RE: Kalm Brewery

Grading Plan

Hydrology File: G19D040

Based upon the information provided in your submittal received 01/16/2018, the Grading Plan **is not** approved for Building Permit and Grading Permit. The following comments need to be addressed for approval of the above referenced project:

GRADING & DRAINAGE

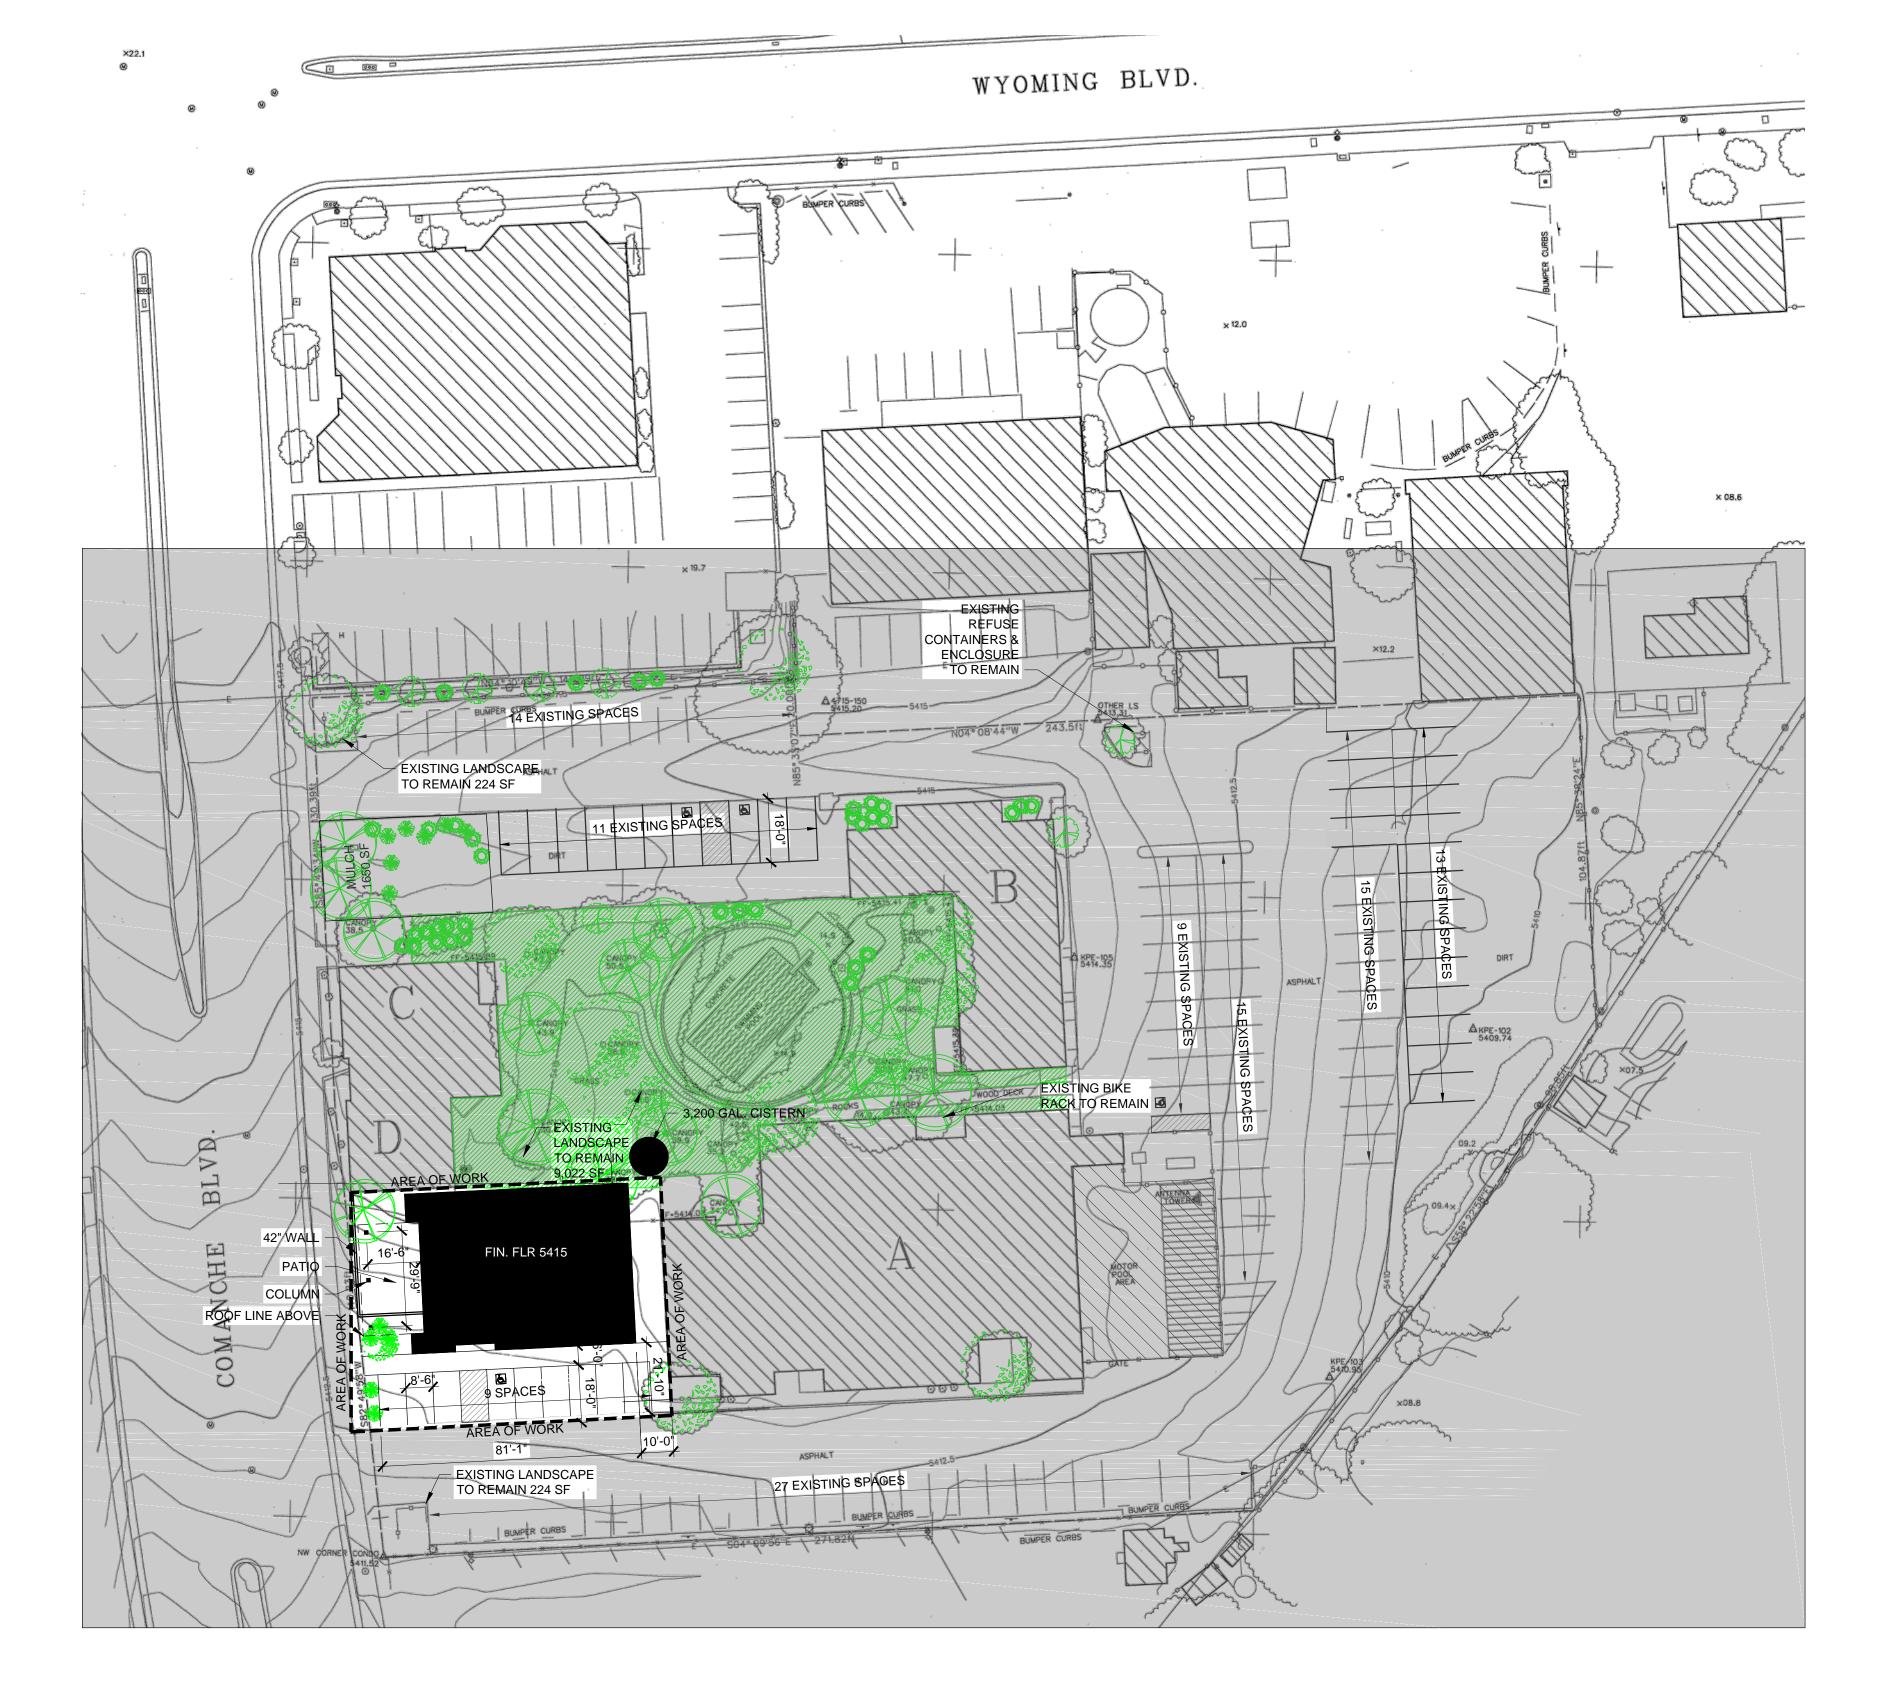
- 1. Per the DPM Chapter 22 Section 7 Grading Plan Checklist, the following must be on the Grading Plan.
 - a. Please provide an engineer's stamp with a signature and date.

- b. Please use 1'' = 20' for the scale.
 - c. Please provide a Vicinity Map.
 - d. Please provide the Benchmark information (location, description and elevation) for the survey contour information provided.

- e. Please provide the FIRM Map and flood plain note with effective date.
 - f. Please provide a legal Description of the property.
- 2. The following engineering information needs to be added per the DPM Chapter 22 Section 7 Grading Plan Checklist.

- a. Please use the procedure for 40 acre and smaller basins as outlined in Chapter 22, Part A of the Development Process Manual (DPM). Please provide both the existing conditions and proposed conditions for the 100 year-6 hour storm event.

- b. Please provide proposed top of curb grades along the parking area and provide proposed grades within the landscaping area.

- 3. The storm water quality volume for this site is required in order to manage the storm water runoff. The storm water quality volume is calculated based on the 0.44 inch storm. To calculate the required storm water quality volume to be captured, multiply the impervious area (SF) by 0.34 inches for the 90th percentile storm. This can be placed within the landscape area however; drainage from the impervious area must first drain to the storm water quality pond prior to discharging into Comanche Rd.
- 4. The discharge from the storm water quality pond to Comanche Rd must be done through a sidewalk culvert. Please provide wier calculations (Chapter 22 of the DPM) for the proposed sidewalk culvert.
- 5. Please reference City of Albuquerque standard detail No. 2236 Sidewalk Culvert with Steel Plate Top at the sidewalk culvert.
